DEPARTMENT OF COMMERCE
Committee of Consumer Services

Date: 9 April 2004

Subject: Recommendations of the Committee of Consumer Services Regarding
Schedule 37: Avoided Cost Purchases from Qualifying Facilities up to 1 MW
No. 03-035-T10

Figure 1

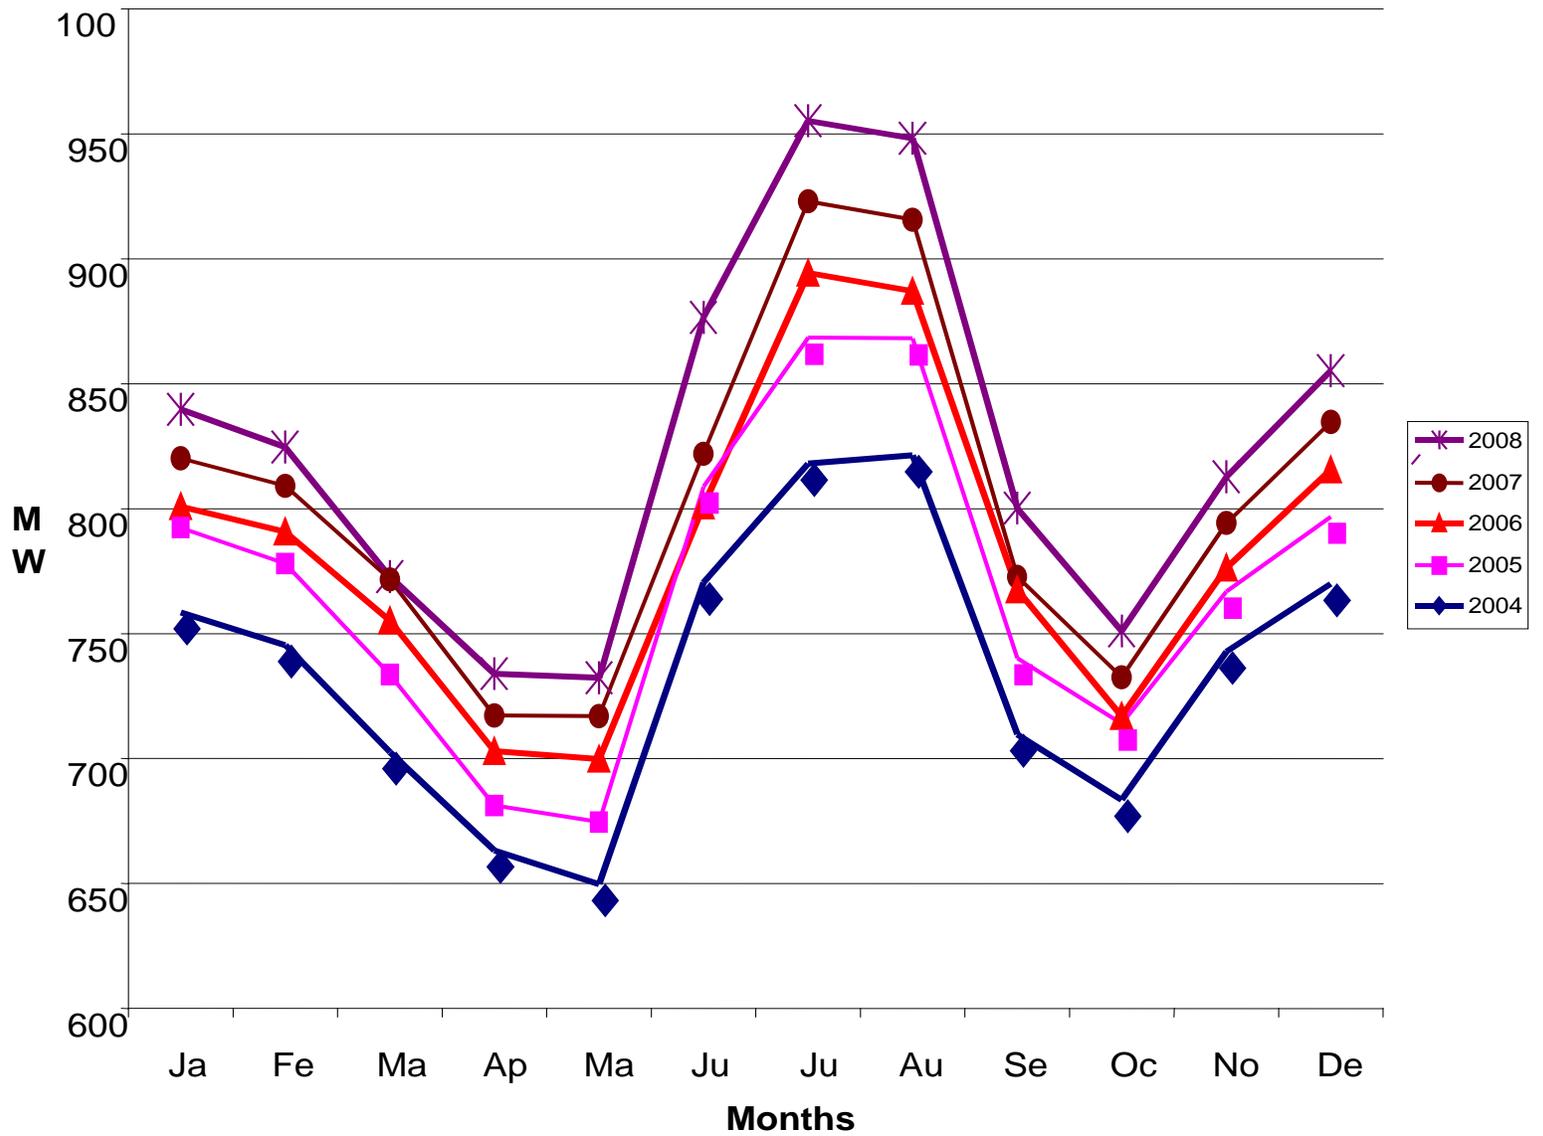
- 2.1 The Committee recommends the Commission limit the definition of the summer period to June through September. PacifiCorp has defined this seasonal period as May through October, which distorts the true summer and winter periods, as well as the corresponding avoided costs.

PacifiCorp defines the summer season to include the six-month period between May and October, and the winter season to include the remaining six months in the year, November through April. However, there doesn't appear to be any support for that seasonal definition when considering PacifiCorp's loads and costs. The summer period is usually the highest load

period, and has the highest average costs in the year. By including both May and October in the summer period, PacifiCorp has included shoulder months that have more in common with the winter period than they have with the summer period. The impact on the avoided cost calculation is that the summer period avoided costs are lower than they should be, and the winter period avoided costs are higher than they should be.

Figure 1 shows the peak loads that PacifiCorp assumes for each month between 2004 and 2008. Figure 2 shows the monthly average system cost as computed using PacifiCorp's GRID model, which was used for the computation of the avoided costs. Each of these graphs show that the months of May and October are dissimilar compared to the other summer months and are more aligned with the winter months. Thus, in the calculation of summer avoided costs only the months of June through September should be included. Alternatively, the months of October through May should be used in the calculation of winter avoided costs.

Figure 3 - PacifiCorp Monthly Deficiency

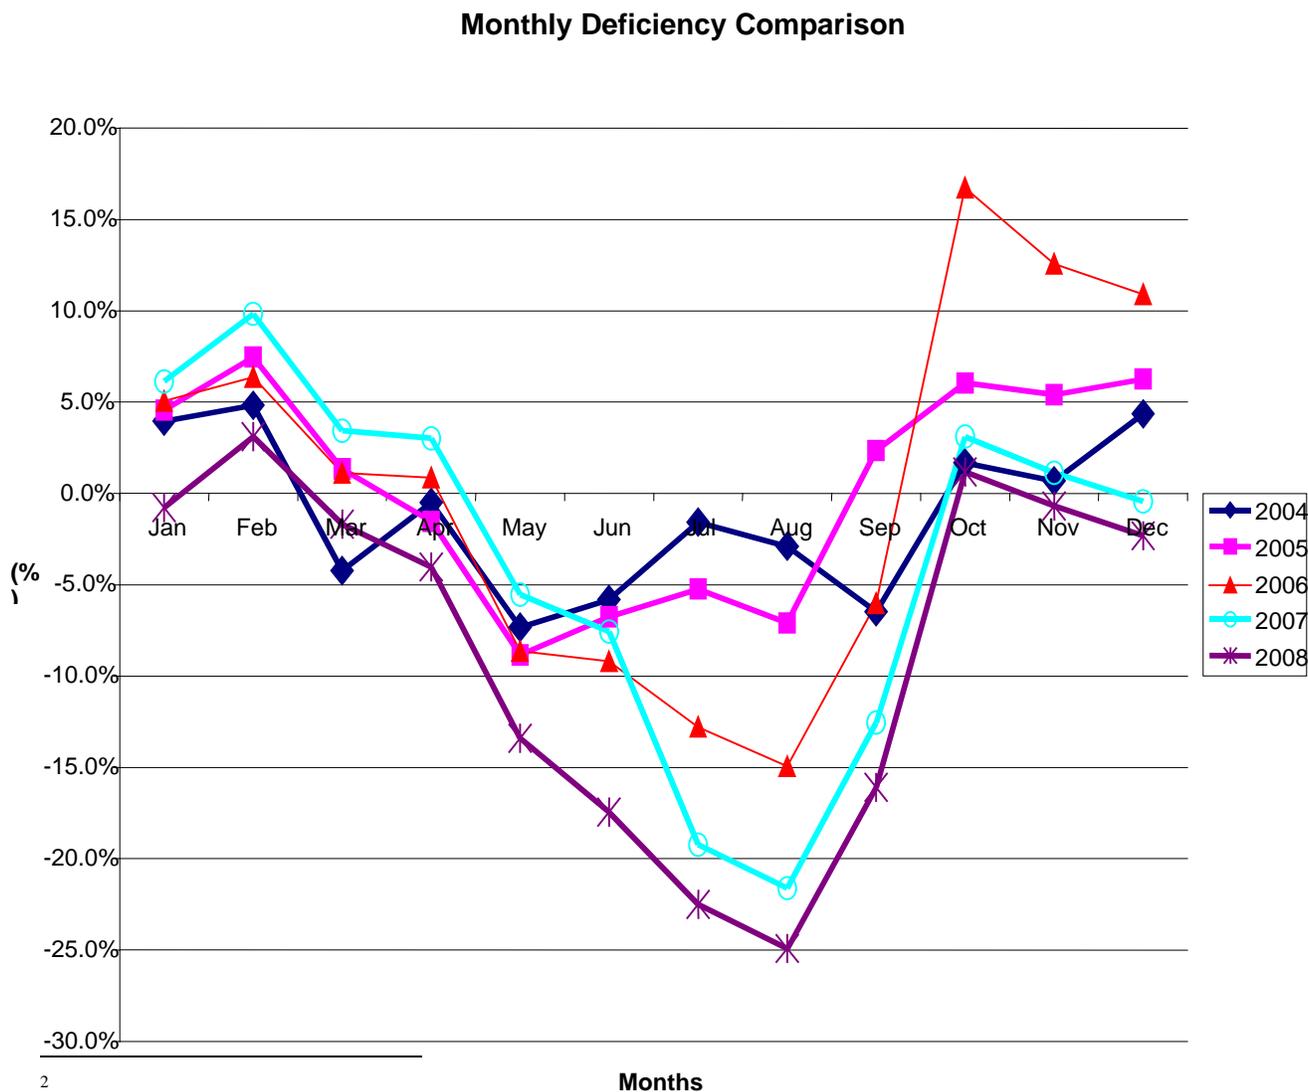
During the years 2004-2006, PacifiCorp proposes to make a capacity payment to QFs only during the three summer months.² In examining the load and resource balance for all 12 months of the year, there are at least three additional months where the Company has a capacity deficiency. The following graph, Figure 3, compares the capacity deficiency for each month of each year between 2004 and 2008. Figure 3 illustrates that during the period of 2004 – 2006, the average number of months per year where a deficit condition occurs is six. For the years 2004-2006, The Committee recommends that the Commission require avoided cost capacity payments be made for at least six months of the year.

- 2.2 The Committee recommends the Commission expand the minimum number of months in which the avoided cost capacity payments should be made from three months to six months. The three months recommended by PacifiCorp does not comport with the number of months it is capacity deficient and thus requires additional capacity resources.

Figure 4
Natural Gas Projections

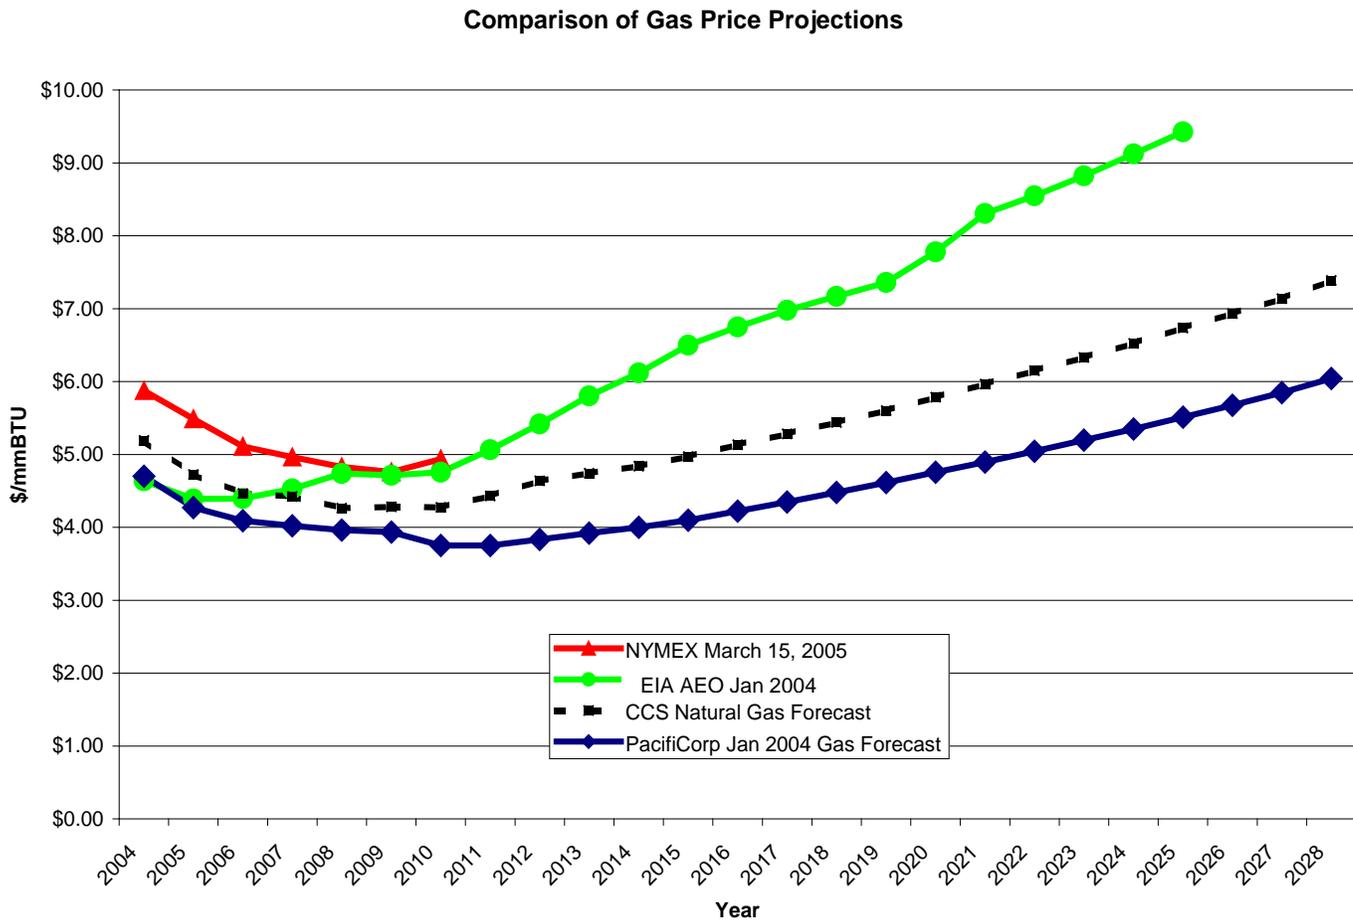
The Committee has conducted a detailed review of the Company's natural gas fuel price assumptions. The Company's natural gas forecast appears to be somewhat low compared with other natural gas forecasts that the Committee has used in its analysis. This comparison led the Committee to develop and recommend its own forecast as an alternative. Figure 4 compares the natural gas price forecasts that the Committee analyzed with the forecast it has developed.

The graph above shows four projections. The Department of Energy's EIA projection is based on the gas price forecast developed for its Annual Energy Outlook, released in January 2004. The NYMEX projection was obtained from the NYMEX website and represents the price today that buyers would be willing to pay for deliveries of natural gas at a future point in time. The Committee's projection was developed as an alternative to PacifiCorp's gas price forecast, which is the lowest forecast on the graph above, and to the NYMEX or EIA forecasts, which represent much higher forecasts. An adjustment to the Committee's forecast has

been made to account for the fact that PacifiCorp is able to take advantage of lower cost gas purchased at the OPAL trading hub, as compared to the Henry Hub, which the other forecasts are based on. The “basis adjustment” amounts to a 40 cents per year reduction in gas prices.

The graph shows that in the short run, EIA, NYMEX, and PacifiCorp’s OPAL forecasts are not significantly different. Over the longer term, the NYMEX forecast appears to be headed in the same direction as the EIA forecast, although the NYMEX forecast only goes out to 2010. The EIA forecast goes out to 2025 and appears to be significantly higher than what PacifiCorp forecasts. PacifiCorp’s price in 2025 is nearly 4\$/mmBtu lower than EIA’s in that year. This will have a significant impact on the avoided energy cost calculation. As a general rule, when avoided energy costs are priced based on the cost of a natural gas CCCT unit, for every \$1/mmBTU increase in the price of natural gas, the avoided energy cost would increase by about \$7/mWh. Assuming a 200 MW QF produces about 1,500 gWh based on an 85% capacity factor, then for every \$1/mmBTU increase in the price of natural gas, total avoided cost payments would increase by about \$10 million. Volatility in the price of natural gas, therefore, can have a dramatic impact on the avoided cost results.

The Committee is comfortable with its forecast of natural gas prices for purposes of developing Schedule 37 avoided cost payments and recommends that the Commission adopt its gas price forecast. However, based on the natural gas price impact just illustrated, the Committee is concerned about locking avoided costs to a single gas price forecast. This may lead to payments that do not reflect actual operating costs at the time payments to the QFs are made, which could harm either the QF or ratepayers.

If the Commission prefers to use actual natural gas prices, the Committee recommends that an additional calculation be performed at the time that avoided cost payments are made to QFs. At some future point in time when a QF delivers power to PacifiCorp, an accounting adjustment could be performed to index the avoided energy cost payment to the actual cost of gas at that time. In developing an index from which an adjustment can be made, an implied heat rate calculation is performed by dividing the annual avoided energy cost by the annual average fuel cost that was used in the avoided cost determination. If the implied heat rate is less than the heat rate of a CCCT, then no further adjustment is necessary as the fuel price is assumed to be reasonable under that circumstance. If the heat rate is determined to be greater than the heat rate of a CCCT, then an adjustment is made to the fuel cost used in the avoided cost calculation. In that case, the actual Opal Hub market natural gas price should be multiplied by the implied heat rate at the time the avoided cost payment is made. This adjustment ensures that QFs are neither underpaid nor overpaid for the energy they provide to PacifiCorp.
